## ADDENDUM #2

To: Prospective Bidders  
From: Porter Co. Dept. of Development & Storm Water Management  
Date: January 19, 2024  
Subject: Carriage Lane Road Storm Sewer and Roadway Improvements

**The construction plans have been revised on Sheets C1.1 and C1.3 to clarify pipe removal limits and correct the existing storm sewer pipe size.**

SHEET	6
OF	21
DRAWING NUMBER	<b>C1.1</b>
1/18/2024 DLZ INDIANA, LLC

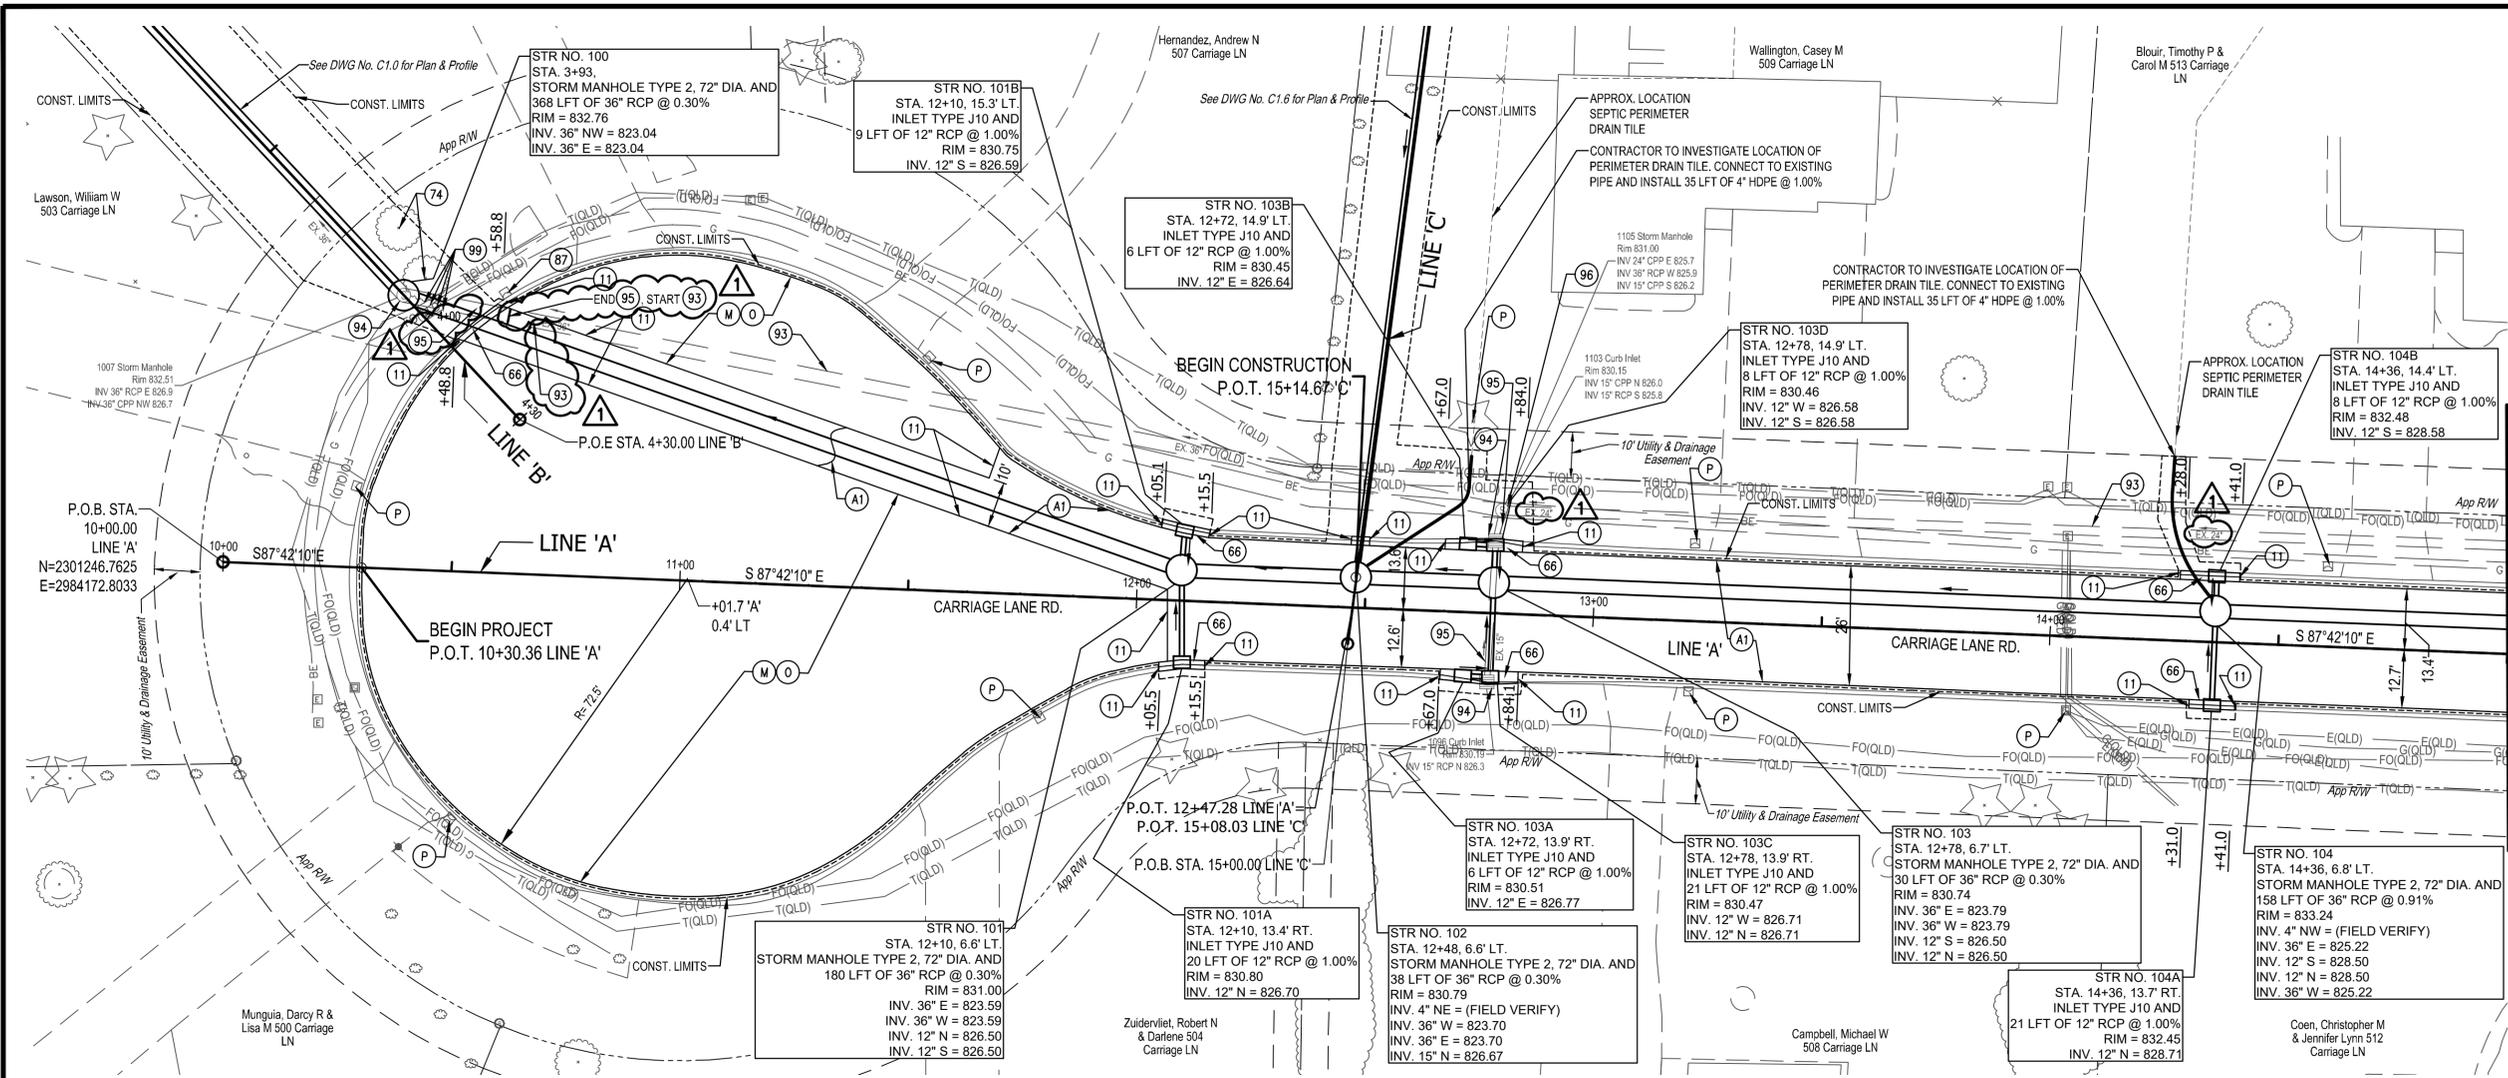
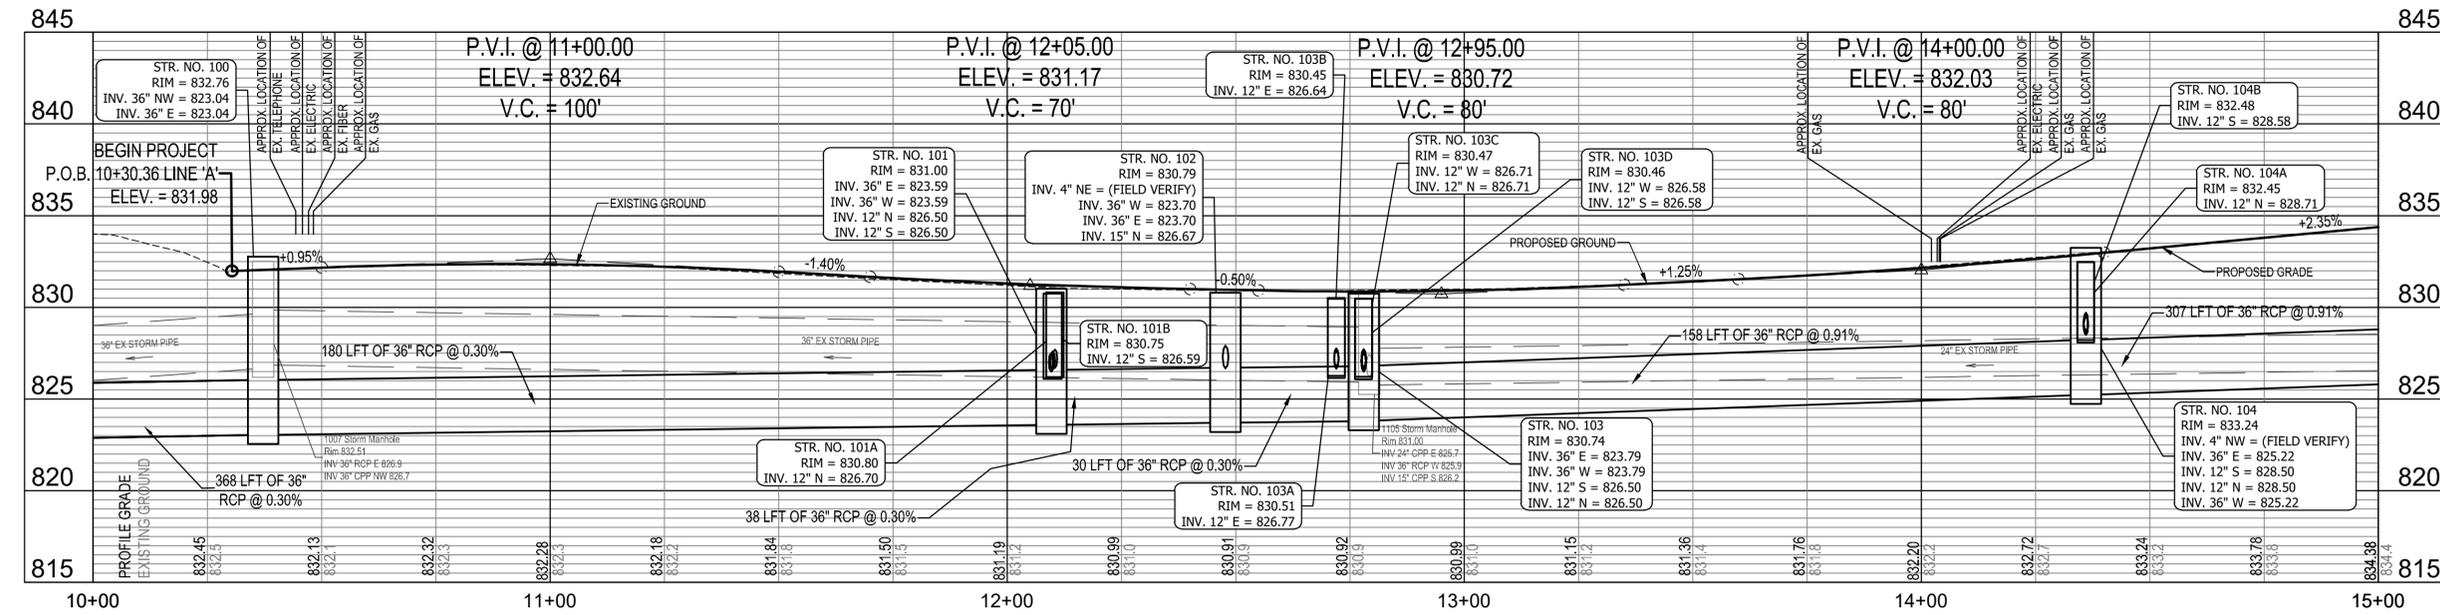
1. Bid Item #12: Pipe Removal – The quantity shown on the bid form is 482 LF however there is no indication to remove approx. 30 LF of existing pipe going East out of Storm Manhole 1007 on sheet C1.1 and it does not appear the 78 LF of existing culvert pipe across Carriage Lane Road on Sheet C1.5 is included in the bid quantity, it appears there is approximately a total of 600 LF of pipe removal, can the bid form be revised to the correct removal quantity?

**The construction plans and bid form have been revised to reflect such changes, as described above.**
2. On sheets C1.0 thru C1.7 the existing buried utilities, telephone, fiber optic, etc. have the letters (QLD) after them, what does (QLD) mean?

SHEET	8
OF	21
DRAWING NUMBER	<b>C1.3</b>

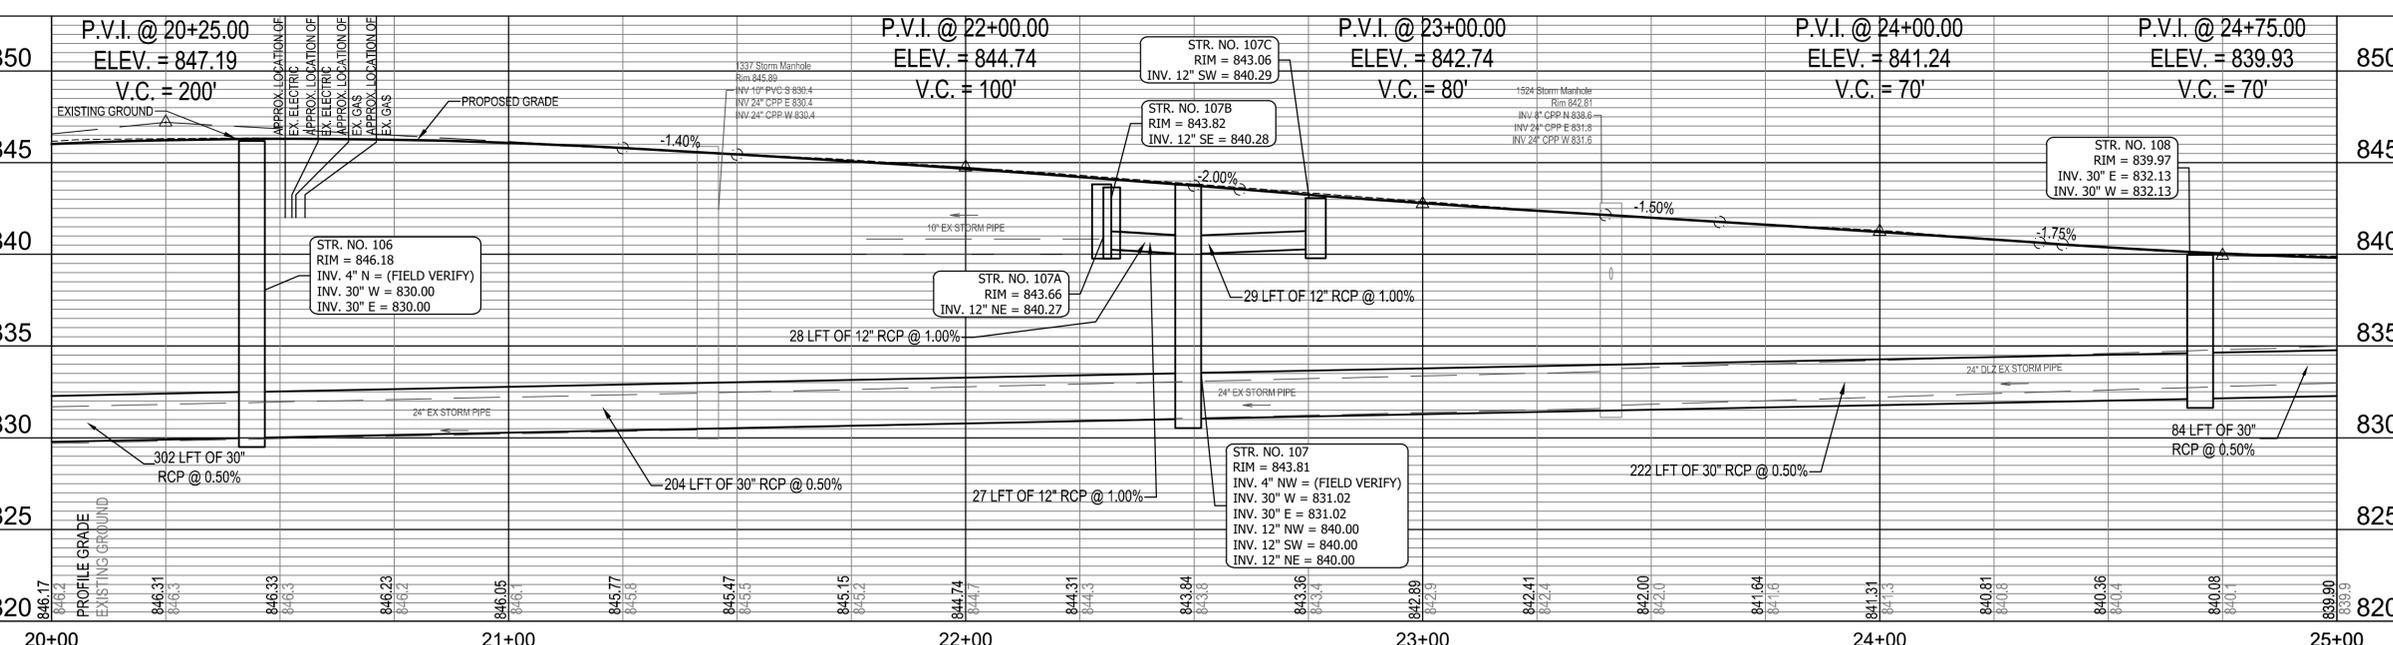
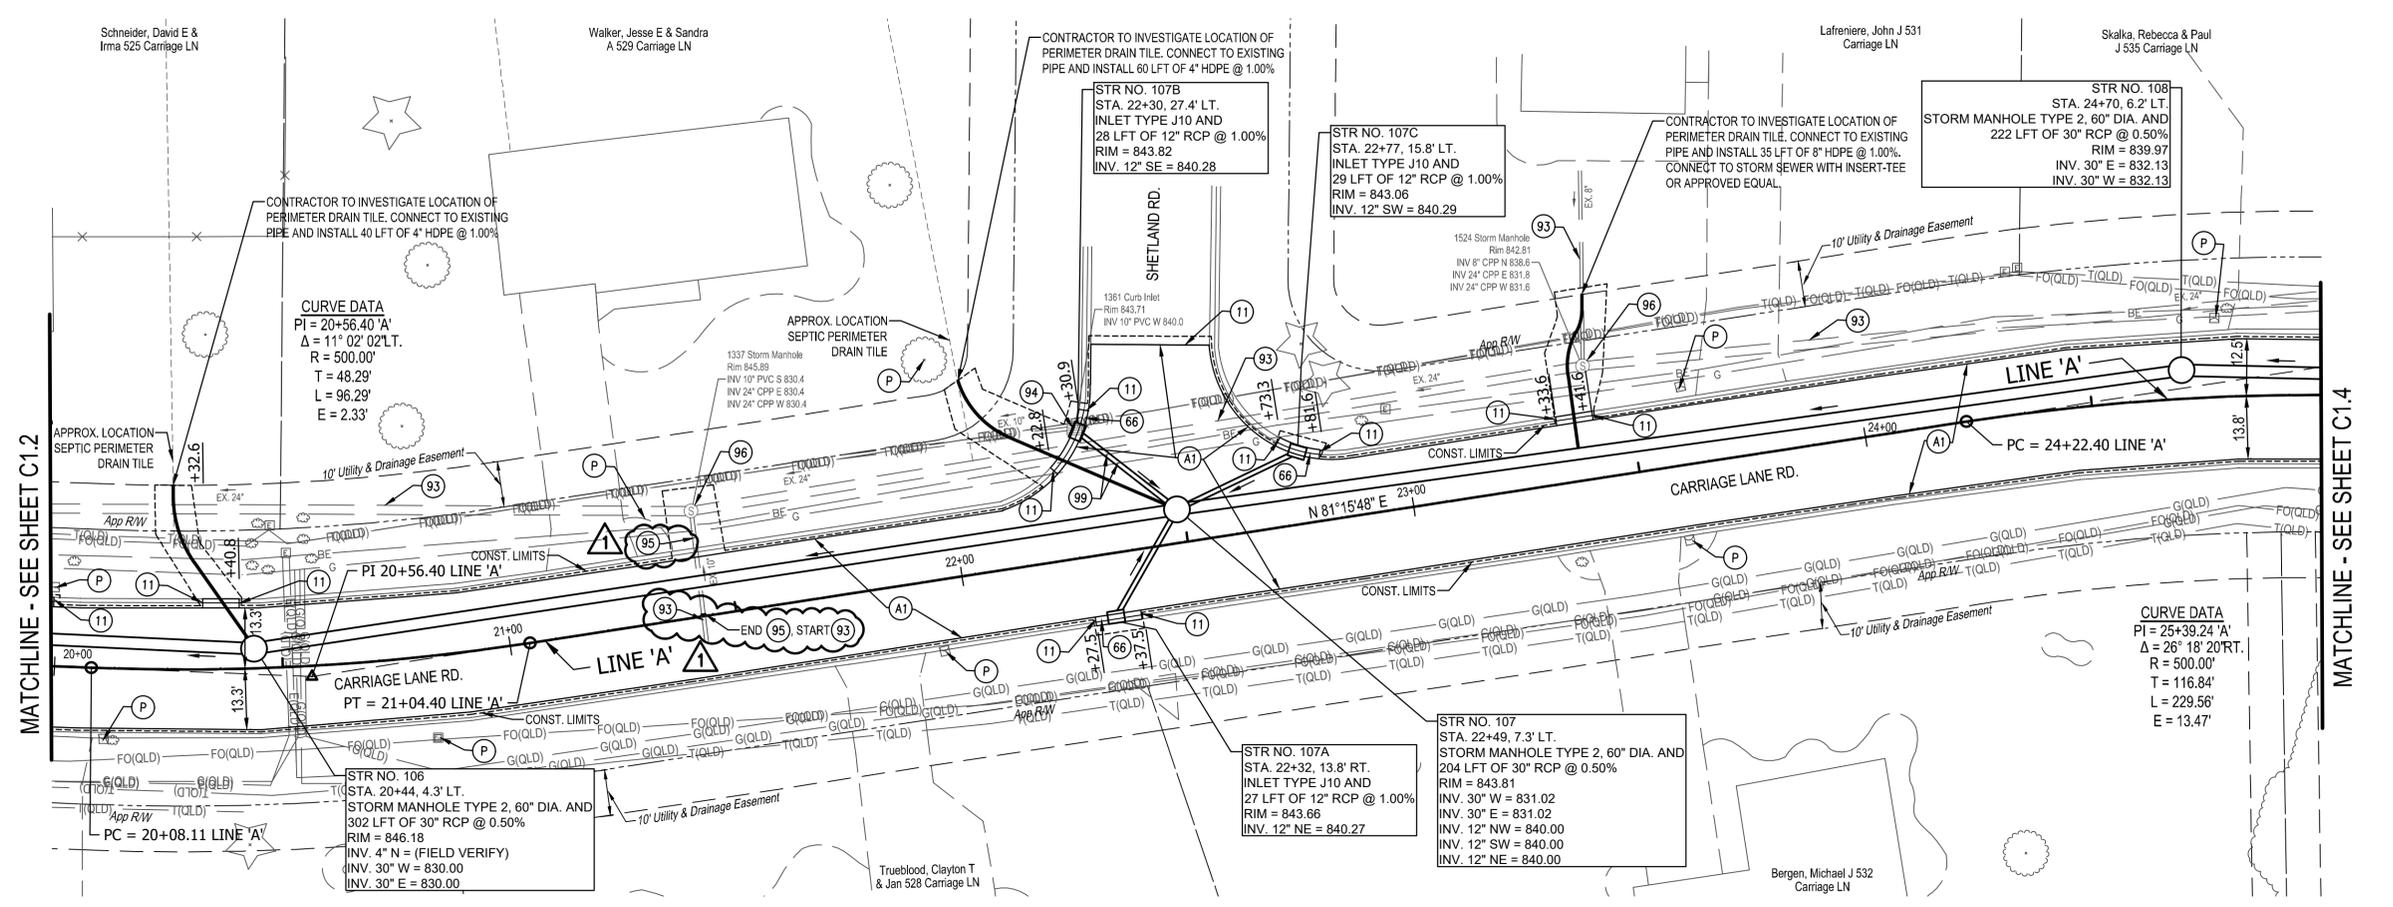
3. On sheet C1.3 there is an existing 10" pipe shown from existing storm manhole #1337 going South which indicates the pipe is to be grouted, the 10" pipe only is shown to just past the centerline of the road, is this the limit of grouting? Please clarify how many feet of 10" pipe we are to grout at this location?

**6 LF of the 10" pipe shall be grout from the limits of pipe removal as shown on the attached plan revisions.**
4. Bid Item #37: Underdrain, HDPE, 6" – The quantity shown on the bid form is 486 LF, however, there are three (3) locations of underdrain (Sheet C1.4 shows 45 LF & 67 LF and Sheet C1.7 shows 415 LF). The total LF of 6" underdrain shown is 527 LF., can the bid form be revised to reflect the actual LF of 6" underdrain shown?
